**ILLINOIS
POWER**

Subject: Clinton Power Station (CPS)
Revision of Response to Bulletin 88-08, Supplement 3

Clarification of Response to NRC Bulletin 88-08 Supplement 3
in Response to the NRC's Letter Dated
November 26, 1991

Figure 1

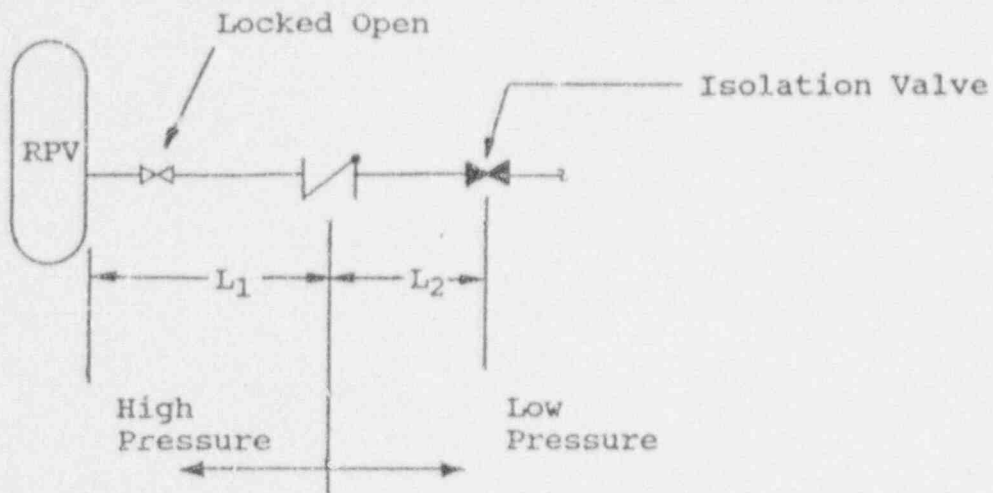
As shown in Figure 1 (p. 4 of 4 of this attachment), the configuration of the five subsystems in question consists of a locked-open gate valve, a check valve, and an isolation valve. It is postulated that a small amount of leakage could flow past the check valve to the isolation valve and then past the valve disk and out the stem of the isolation valve. This leak would slowly heat up the disk causing it to seat tightly. Leakage flow would then cease, allowing the disk to cool and subsequently contract. This cycle would then resume after the disk cooled. This cyclic phenomenon would reduce the life of the associated piping between the reactor pressure vessel (RPV) and the isolation valve due to fatigue. If, however, the isolation valve was of sufficient distance from the hot source (the RPV in this case), enough heat would be lost to the environment and enough mixing would occur such that there would be insufficient heat available to drive this cycle. The distances between the RPV and the isolation valves for our five applicable subsystems are significantly greater than 25 pipe diameters. ILS puts these five subsystems outside the scope of Bulletin 88-08, Supplement 3, based on the evaluation criteria provided by the NRC. Increased surveillance through IP's ISI Program as discussed in IP's response to Action 3 of Bulletin 88-08 for Supplement 3 (letter U-601693 dated June 22, 1990) will consequently not be necessary.

SUBSYSTEM	L ₁	L ₂	Remarks
1V.P-01	>25D	>>25D	L ₁ +L ₂ >>25D
1HP-01	>25D	>>25D	L ₁ +L ₂ >>25D
1RH-01	>25D	>19D	L ₁ +L ₂ >>25D
1RH-03	>25D	>>25D	L ₁ +L ₂ >>25D
1RH-05	>15D	>>25D	L ₁ +L ₂ >>25D

Based on the NRC-provided evaluation criteria, Supplement 3 of Bulletin 88-08 requires no further action for the five subsystems noted above.

Figure A

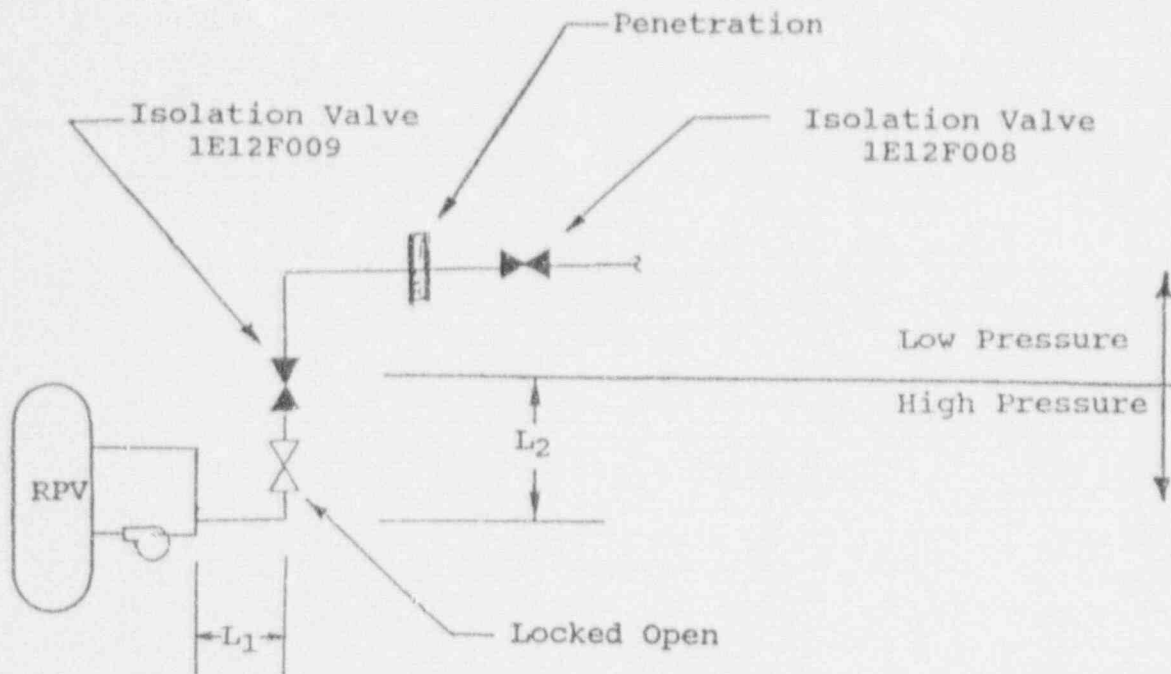
Subsystem 1RH-34 begins at the connection to the 20-inch Reactor Recirculation (RR) Pump "B" suction line and ends at the penetration anchor for containment penetration LMC-14. The portion of piping considered as unisolable from the Reactor Coolant System (RCS) includes the portion of the line from the RPV up to valve 1E12-F009. A simplified schematic is shown in Figure A (p. 3 of 5 of this attachment).

SUBSYSTEM	L_1	L_2	REMARKS
1RH-34	~ 4-1/2'	~ 16'	$L_1 + L_2 < 25D$

NOTE: L_1 is a Horizontal Run.
 L_2 is a Vertical Run.
This case has been analyzed for thermal stratification and found to be acceptable.

- A. Loadings at the connection between the RH piping and the 20" RR "B" suction line were unchanged.
- B. Piping stresses and usage factors remained within the allowable ASME Code limits.
- C. Load increases on supports were evaluated and were found to be acceptable.
- D. Load increases at the containment penetration (LMC-14) from the subsystem 1RH-34 analysis were analyzed and were found to be acceptable.

Figure B

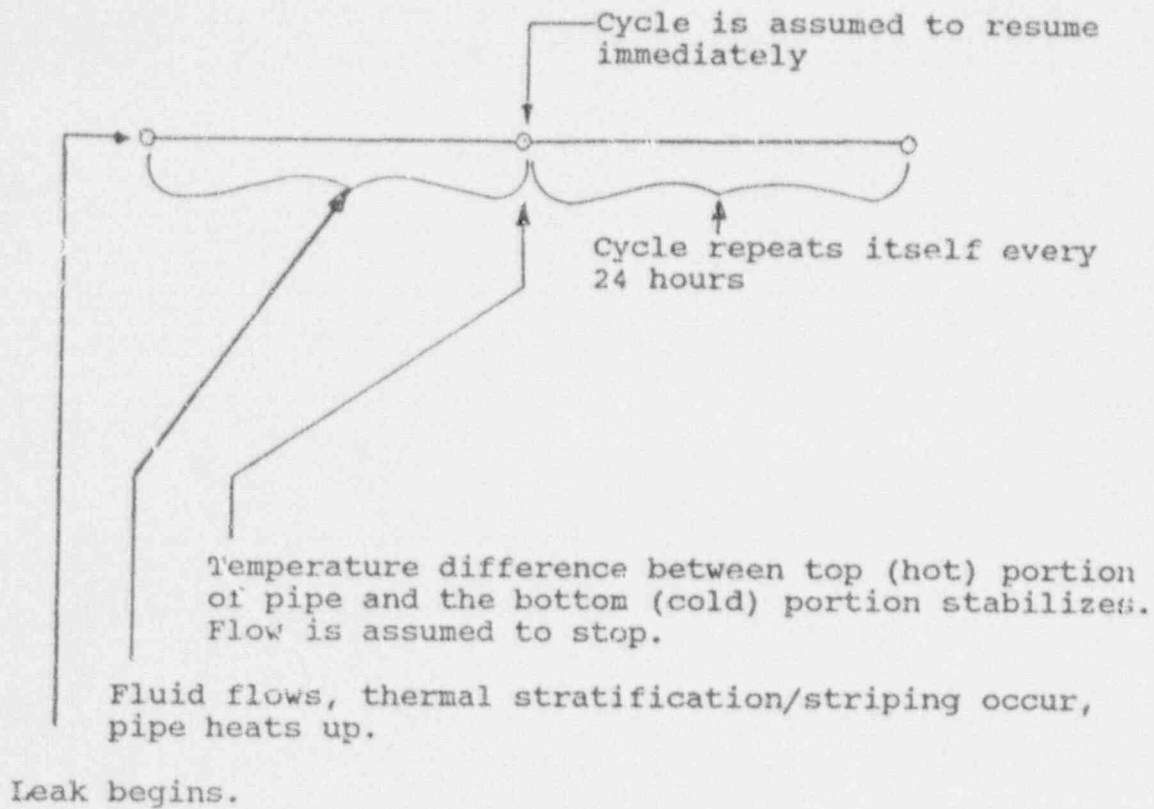
Original Analysis

- Piping is subjected to continuous fatigue cycles.
- Cycle restarts every 24 hours.

Figure C

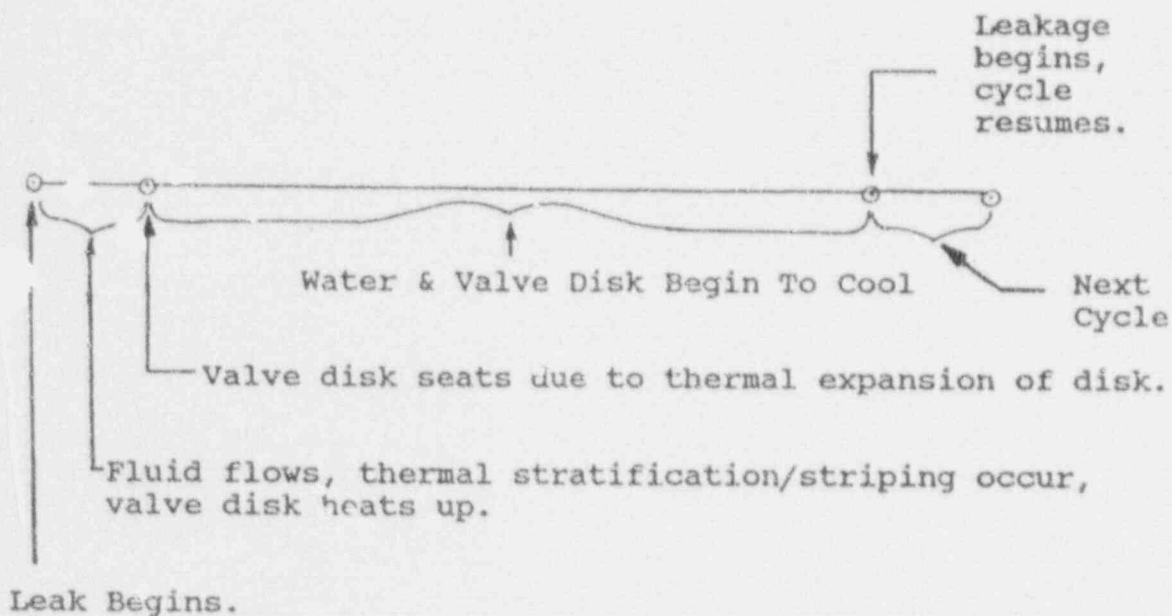
More Accurate Analysis

- Piping experiences thermal fatigue cycles induced by thermal stripping for a 7-hour duration.
- A 45-hour cooldown occurs. During this time period the piping does not experience fatigue cycles induced by thermal stripping.
- The 7-hour cycle restarts after cooldown.

NOTE: The first attempt to qualify the penetration itself was done using the fatigue cycle analysis discussed previously. This resulted in unacceptable fatigue loading. The original fatigue cycle analysis was revisited and a number of assumptions were determined to be overly conservative. In the new analysis, consideration was given to cooldown of the line and heat up of the valve disk as these mitigating effects were not included in the original analysis. A re-evaluation was performed to more accurately model the fatigue cycles. A graphical comparison of the two analyses is given by Figures B and C (pages 4 and 5 of this attachment). Based on the more accurate analysis, 6,739 stratification and 375,407 striping cycles would occur. The penetration was successfully qualified using the fatigue cycles from this more accurate analysis. Subsystem 1RH-34 was not reanalyzed using the more accurate fatigue analysis since the results using the original analysis were acceptable as is.
